REVISED RESPONSE TO REQUEST FOR ADDITIONAL INFORMATION**APR1400 Design Certification****Korea Electric Power Corporation / Korea Hydro & Nuclear Power Co., LTD****Docket No. 52-046****RAI No.: 318-8337****SRP Section: 15.06.05 – Loss of Coolant Accidents Resulting From Spectrum of Postulated Piping Breaks Within the Reactor Coolant Pressure Boundary****Application Section: 15.6.5****Date of RAI Issue: 11/24/2015****Question No. 15.06.05-2****SBLOCA Break Spectrum Analysis & Core Two-Phase Level**

Response – (Rev. 1)

Figure 15.6.5-26A 93 cm² (0.1 ft²) Break in Pump Discharge Leg: Normalized Total Core Power

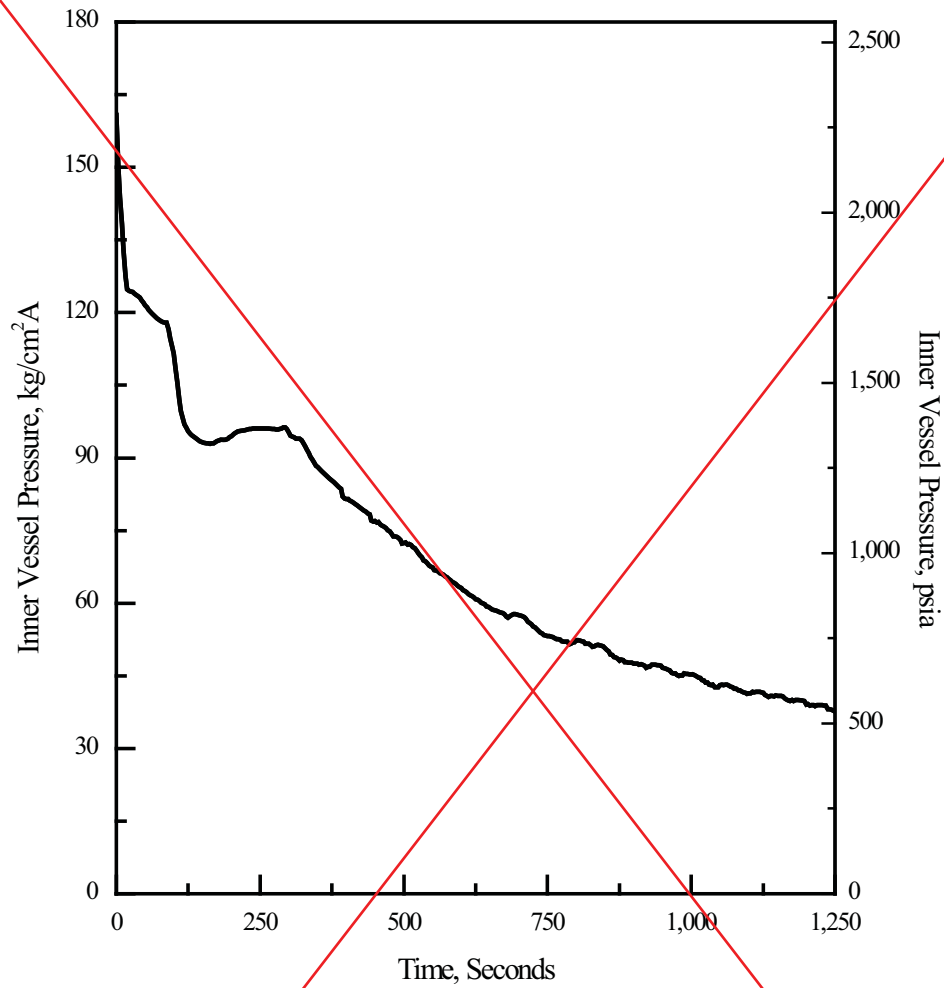
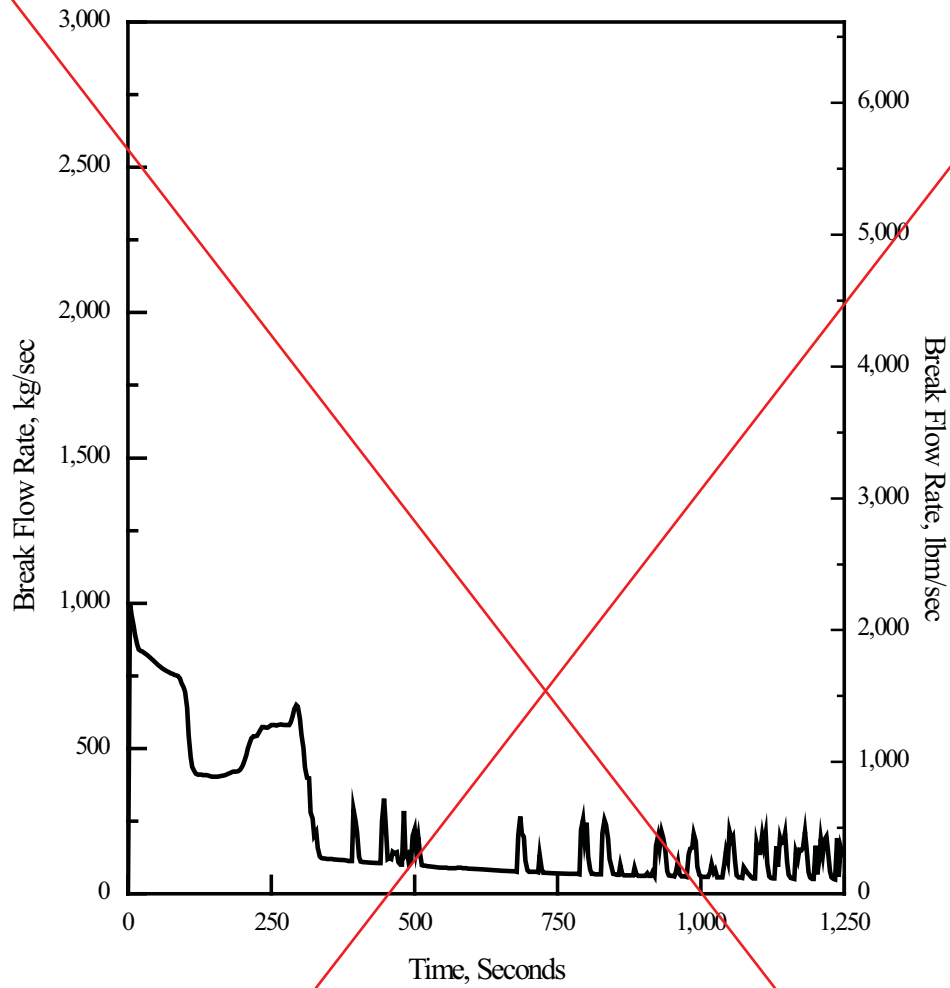
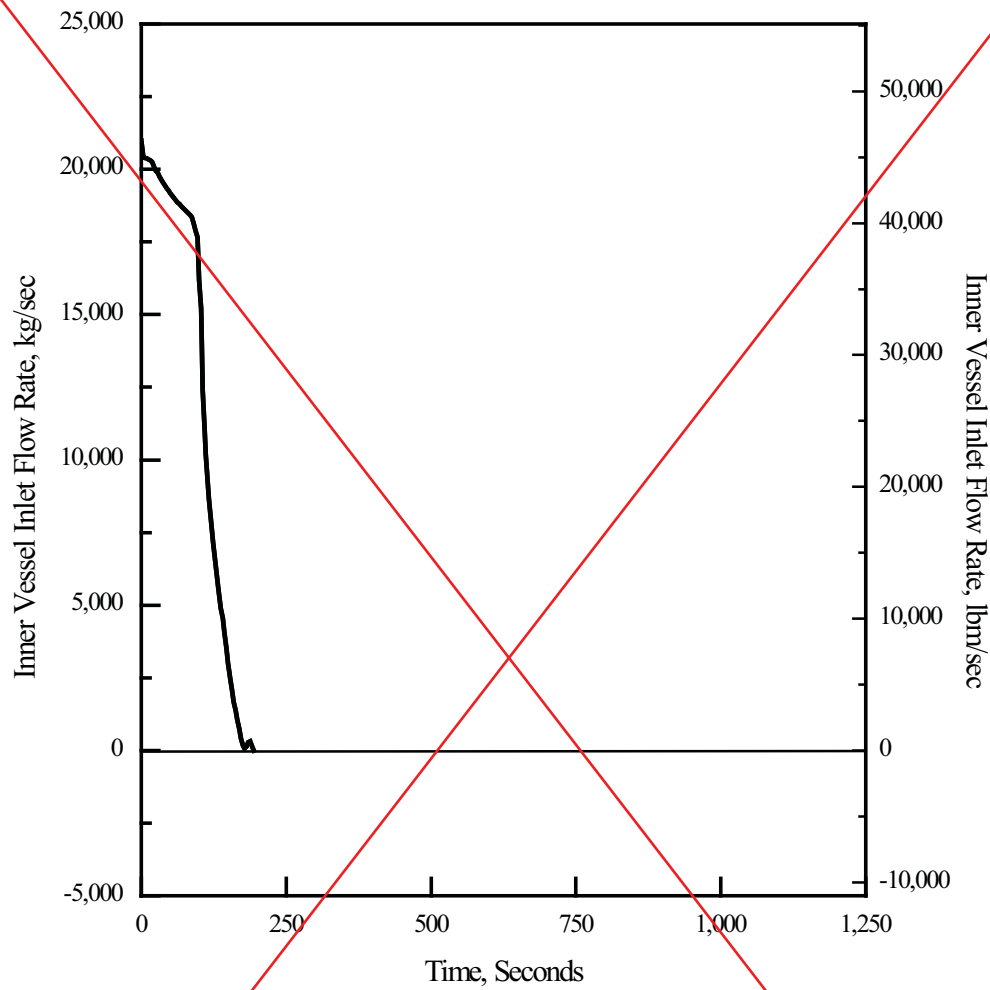
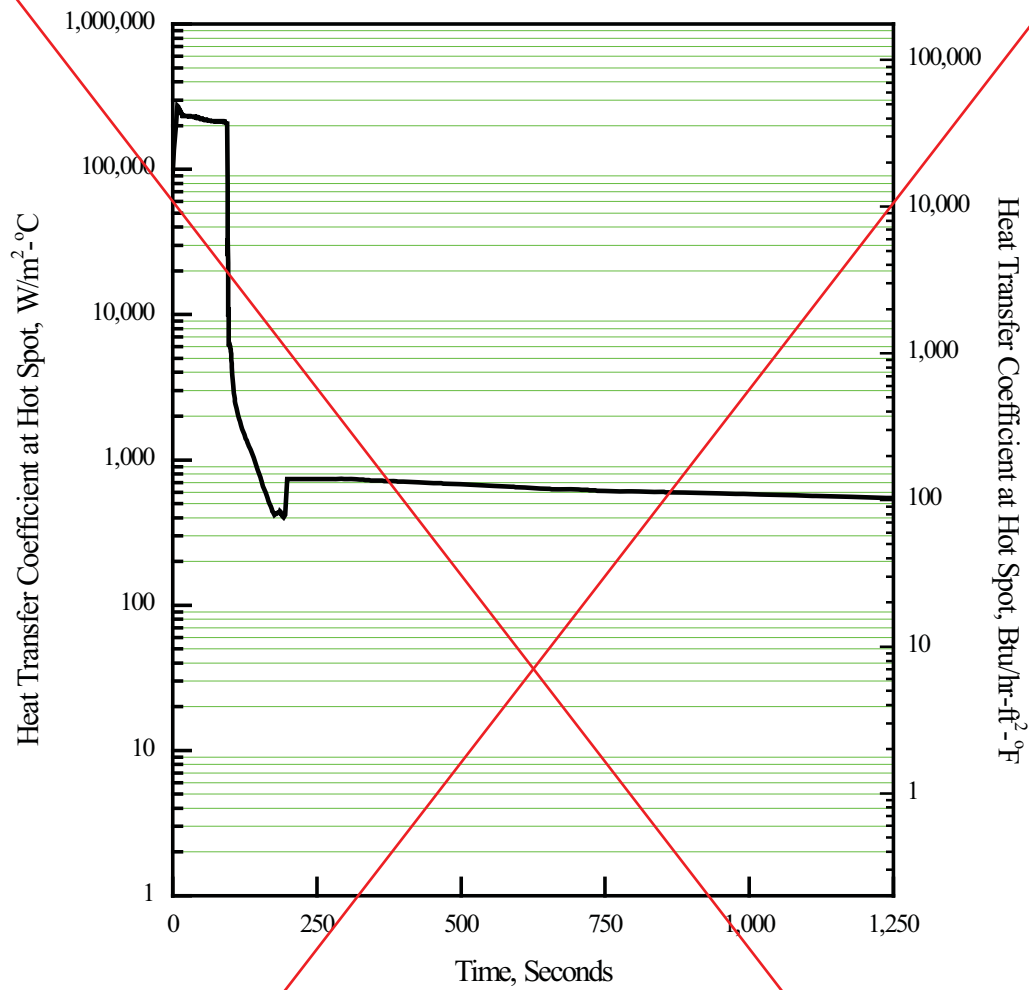
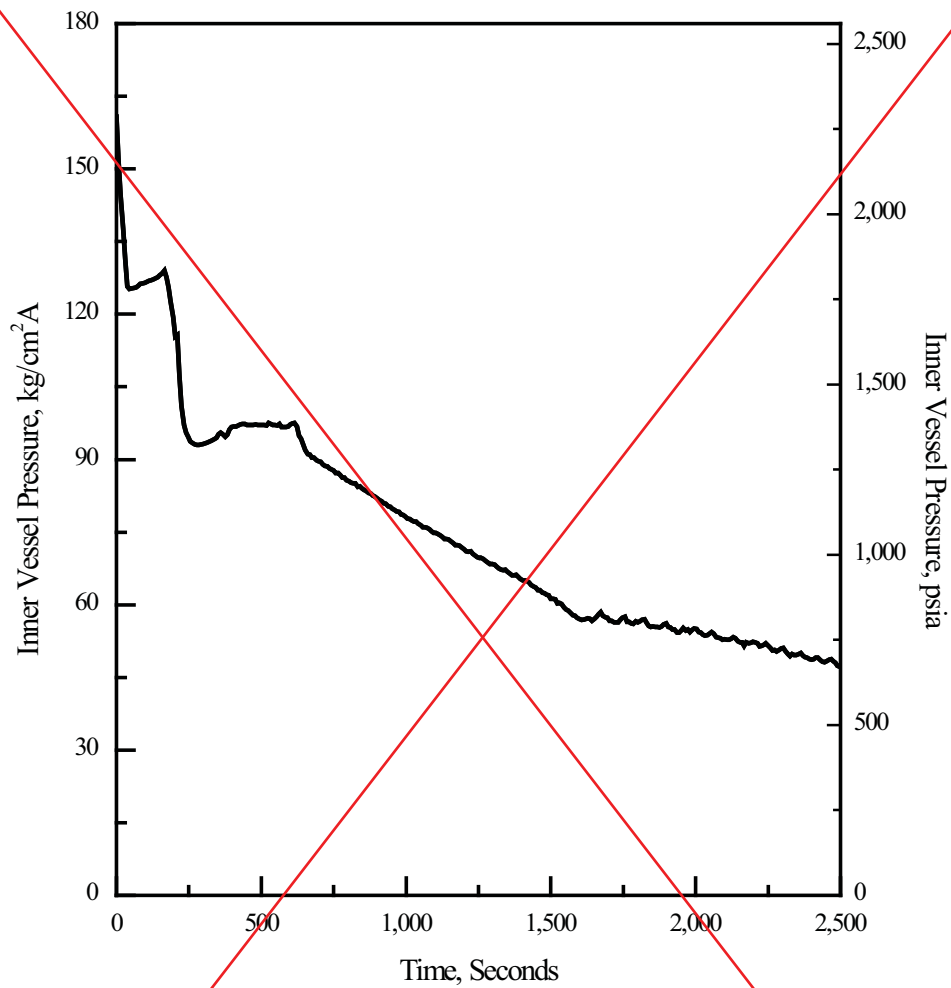
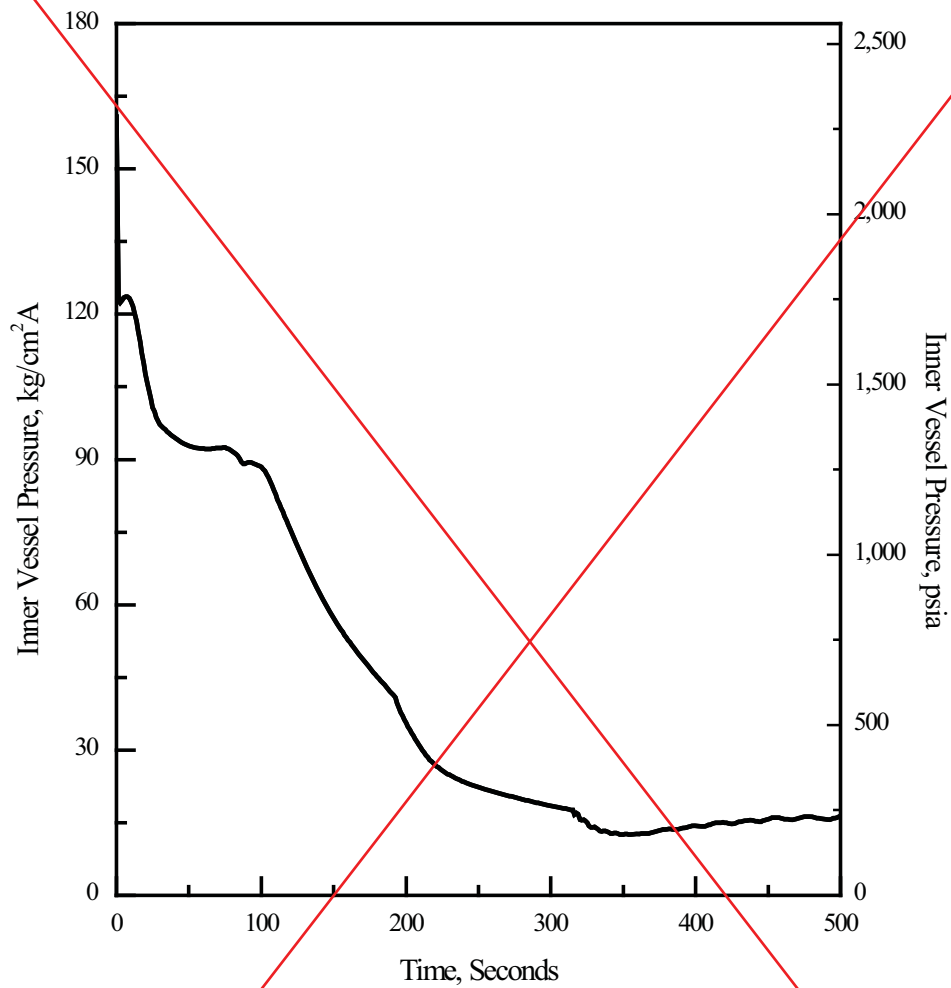
Delete From Figure 15.6.5-26A

to Figure 15.6.5-32H

A**Figure 15.6.5-26 Peak Cladding Temperature vs. Break Size**

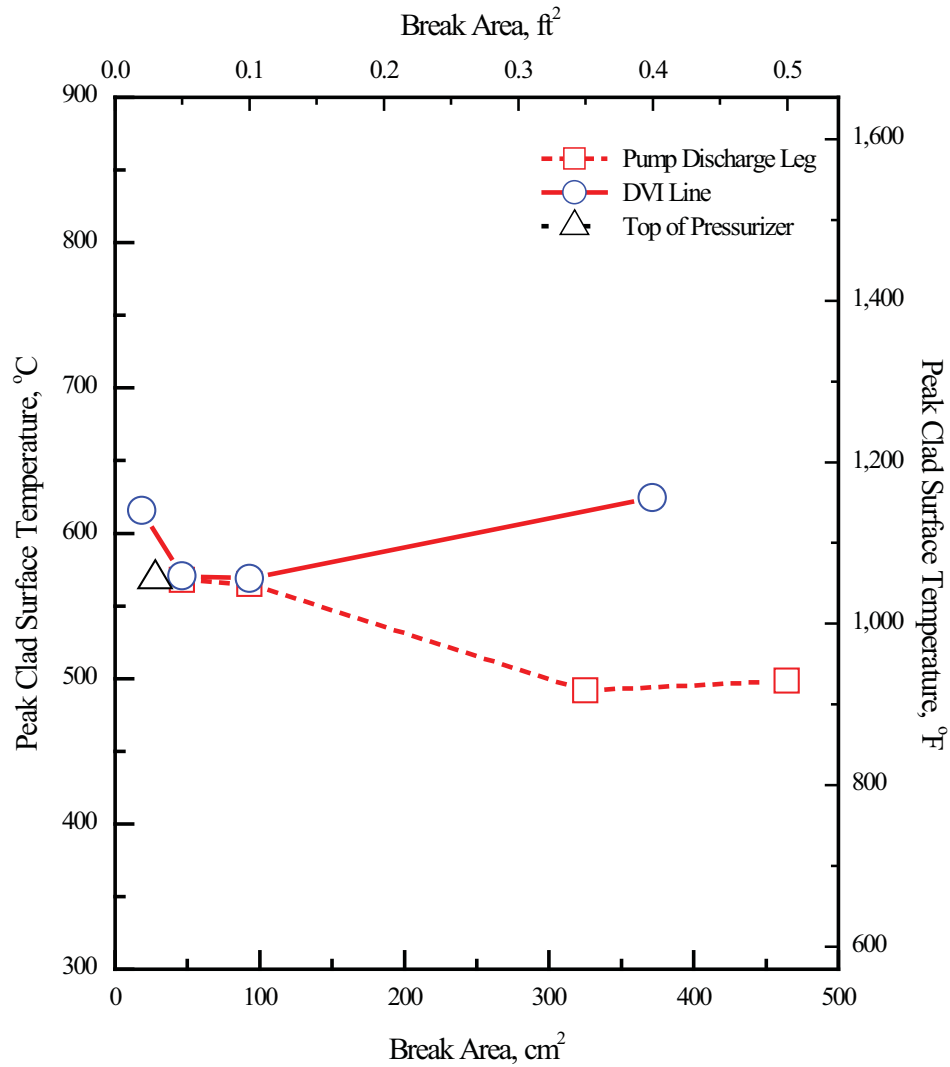
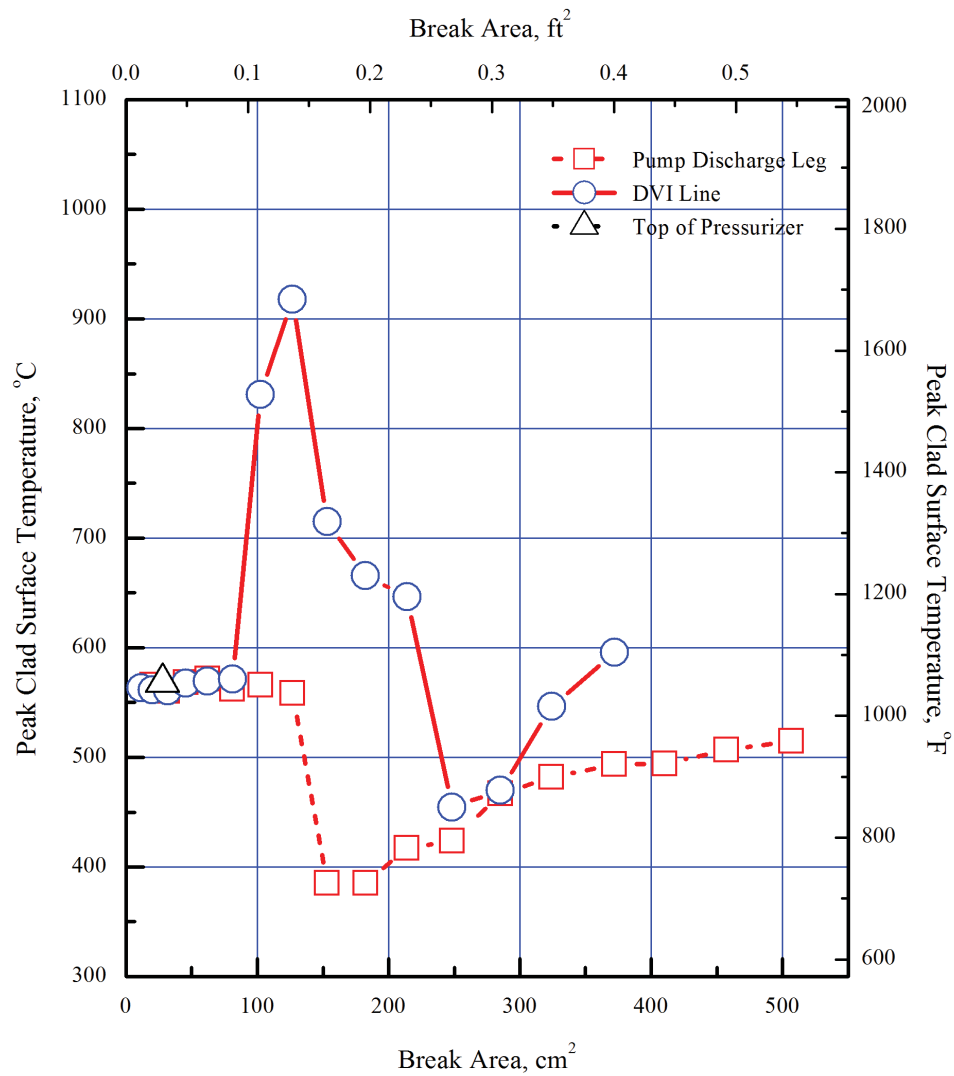
The break spectrums presented in Table 15.6.5-10 of the DCD are insufficient to ensure that the limiting SBLOCA has been identified. Both the direct vessel injection (DVI) and the pump discharge leg (PDL) break spectrums show a trend of increasing PCT for decreasing break size. It is therefore possible that a break smaller than the smallest break analyzed could be more limiting. The SRP Section 15.6.5 notes that in the analysis of small breaks, evaluating integer diameter break sizes (i.e., 1, 2, 3, 4-inch, etc.) is considered insufficient to determine

the worst break because the break areas associated with these integer diameters are too coarse to adequately identify the highest PCT. The applicant is requested to provide the results of a finer break spectrum for both the DVI line and PDL breaks to establish that the ECCS will function to meet acceptance criteria specified in 10 CFR 50.46. The results must include the PCT as well as the number of loop seals clearing for each SBLOCA break size in the following table.

According to the proposed finder break size table, the dense break spectrum analysis for small break LOCA of APR1400 are performed for the DVI line break and PDL break. The results of dense break spectrum are shown in the Table 8337-1~3 and Figure 8337-1~33, respectively.

~~Figure 15.6.5-33~~ Peak Cladding Temperature vs. Break Size

Figure 4.2-4 Peak Cladding Temperature vs. Break Area

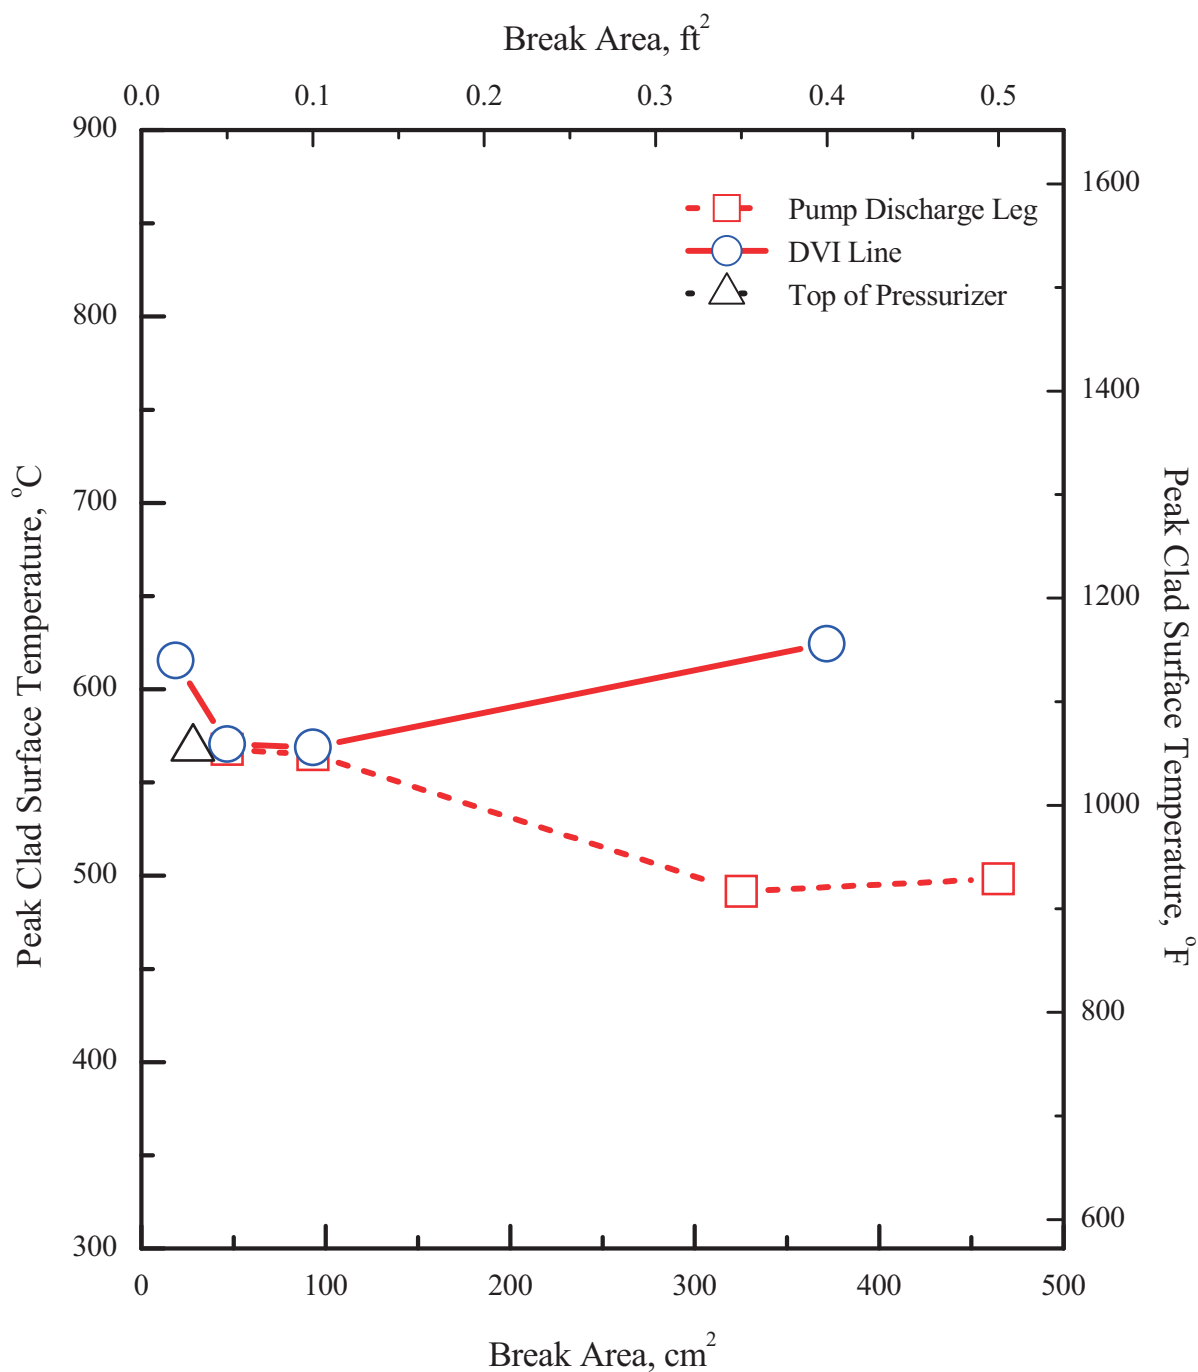
Replace with A
(Next 1 page)
